# Staff Report

**To:** Salt Lake City Planning Commission  
**From:** Katia Pace, 801-535-6354, [katia.pace@slcgov.com](mailto:katia.pace@slcgov.com)  
**Date:** December 15, 2021  
**Re:** PLNPCM2021-00898, 1301 S State Street - Coachman Mixed Use - Planned Development

**REQUEST:** Ryan Mackowiak, representing the property owner, is requesting a Planned Development to build the Coachman Mixed Use. The development would consist of a 5-stories building and underground parking. Above the underground parking it will have restaurant/commercial on the street level, structured parking/storage space on the second level, and approximately 112 condominiums on the three floors above. The project will be studios, 1-bedroom & 2-bedroom owner occupied condos.

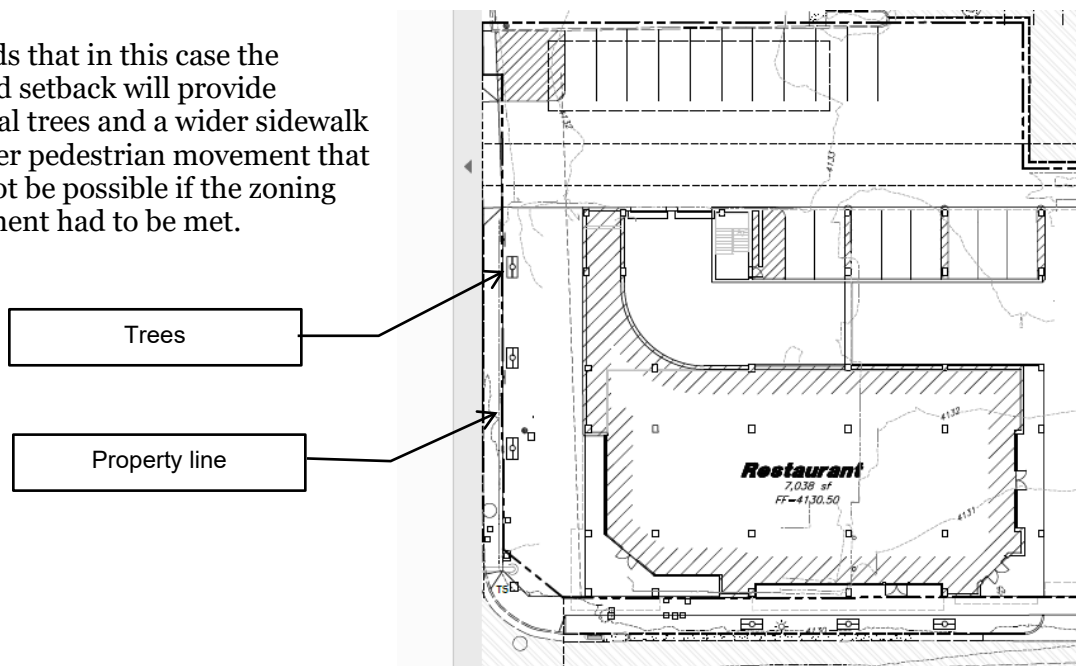
The other requested modification is to have the building façade facing 1300 South to be built 23 feet from the property line. The maximum corner yard setback is 10 feet with a minimum of 50% of street facing facade having to be built with no setback. Locating new buildings at or near the front property line helps to engage sidewalk activity, providing visual interest and variation for pedestrians. However, the front yard facing 1300 South will need to be extended beyond the 50% maximum allowed because of existing power lines that will prohibit construction under it. Also, the sidewalk on 1300 South is approximately 5 feet with a tight room for pedestrian movement. The applicant is proposing a 23-foot setback to provide a pedestrian walkway with trees along the sidewalk.

Staff finds that in this case the increased setback will provide additional trees and a wider sidewalk and better pedestrian movement that would not be possible if the zoning requirement had to be met.

**Site Plan**  
**Coachman Mixed Use**  
 1301 South State Street  
 Salt Lake City, UT

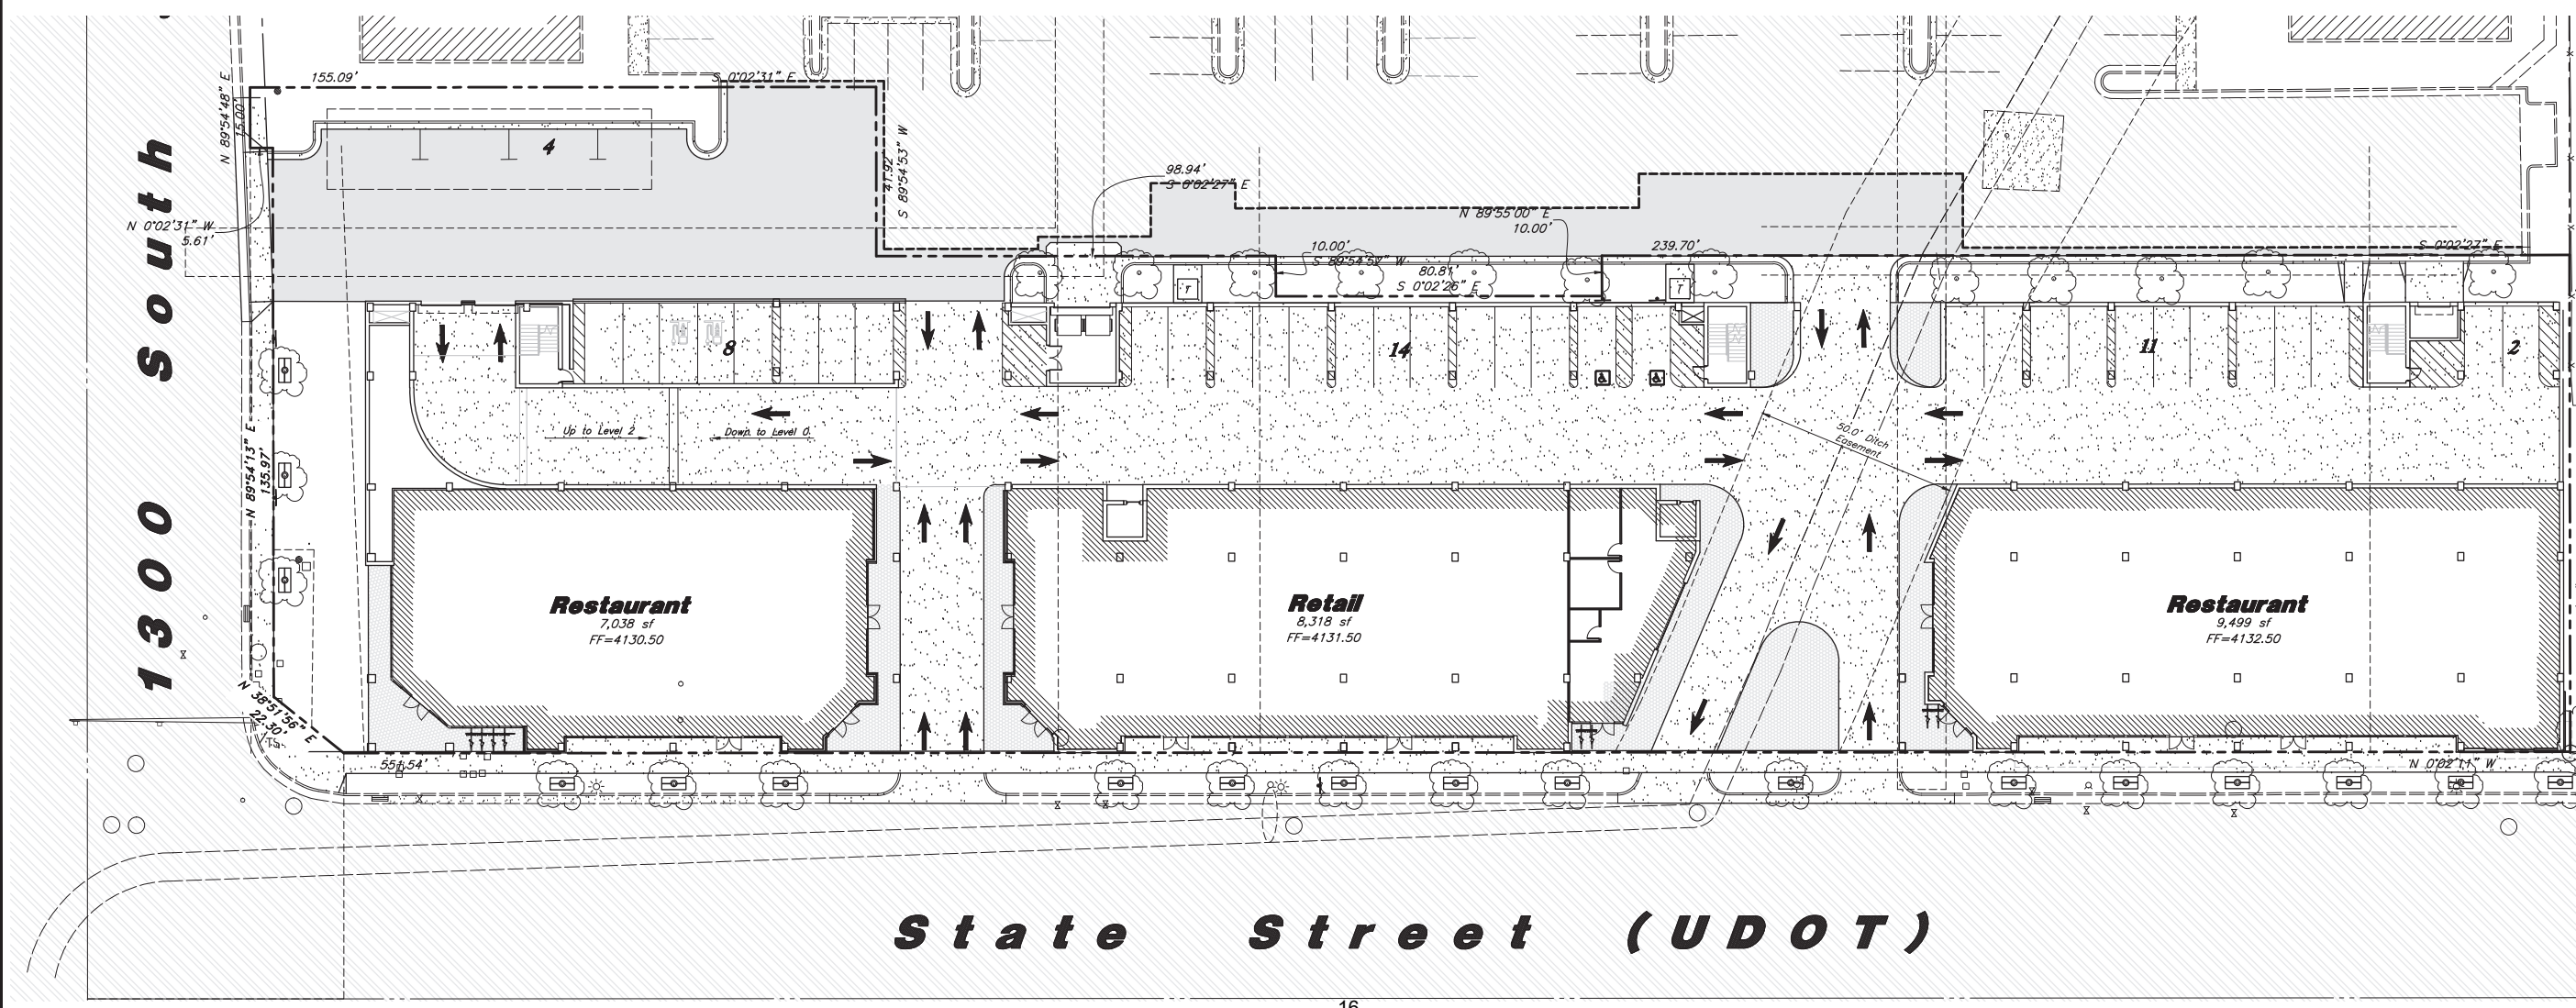
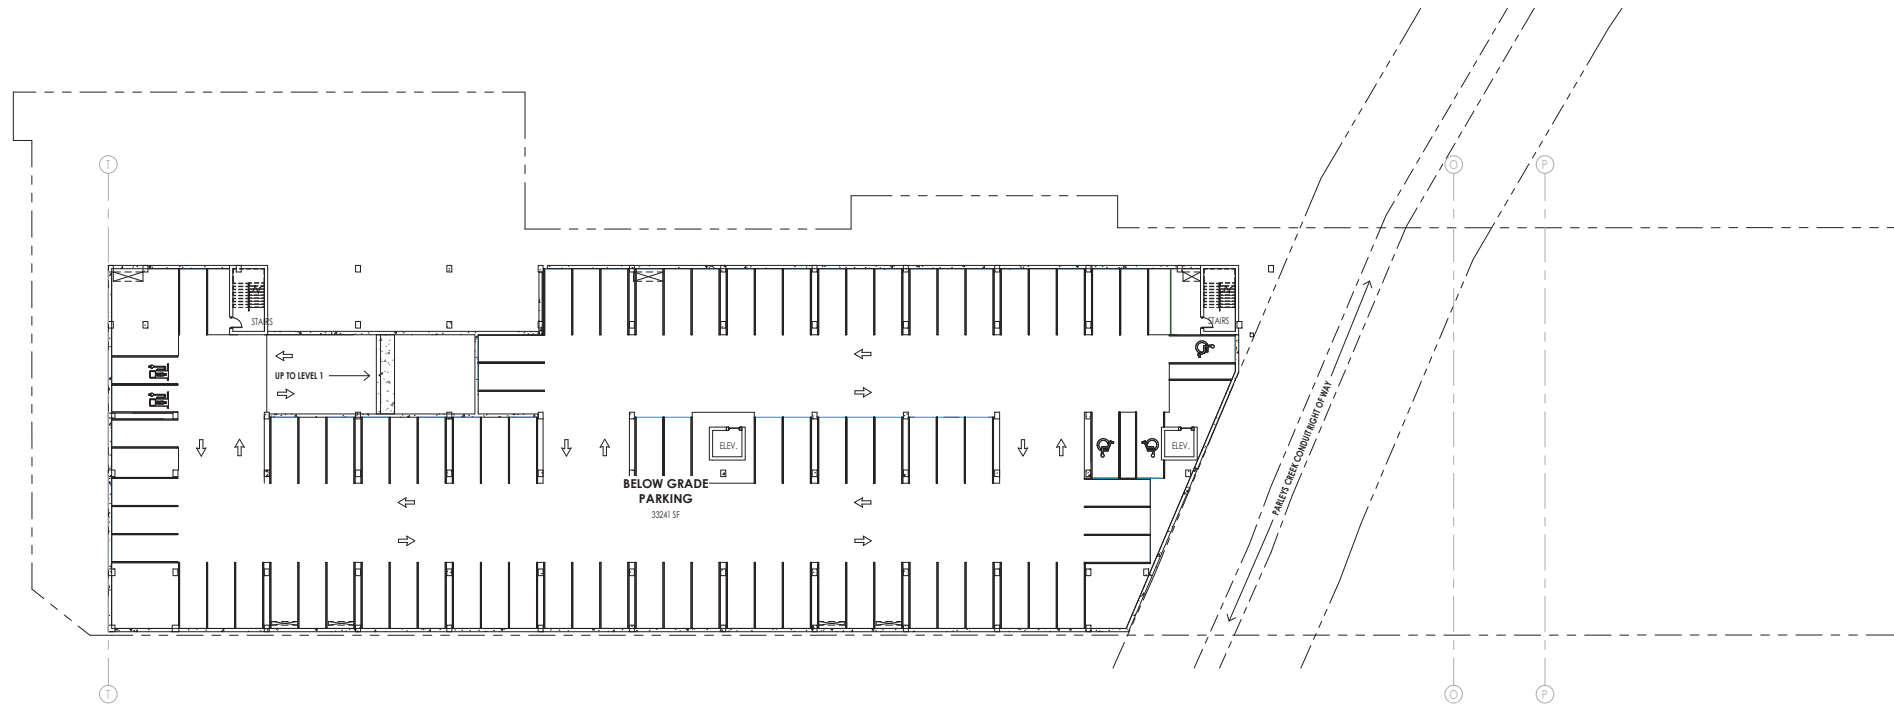
1. Provide a site plan, drawn to scale and fully dimensioned, showing any off-street parking or loading facilities to be provided. Include dimensions for parking stalls and aisle widths.

4. Show the required ten-foot sight distance triangles for each driveway at the intersection of the back of the sidewalk and the driveway (see 21A.40.120.E and 21A.62.050, Illustration I).

5. The required bicycle parking must be located outside. The bike room shown on the plan can remain, but the required bicycle parking must meet location standards per 21A.44.050.B.4.
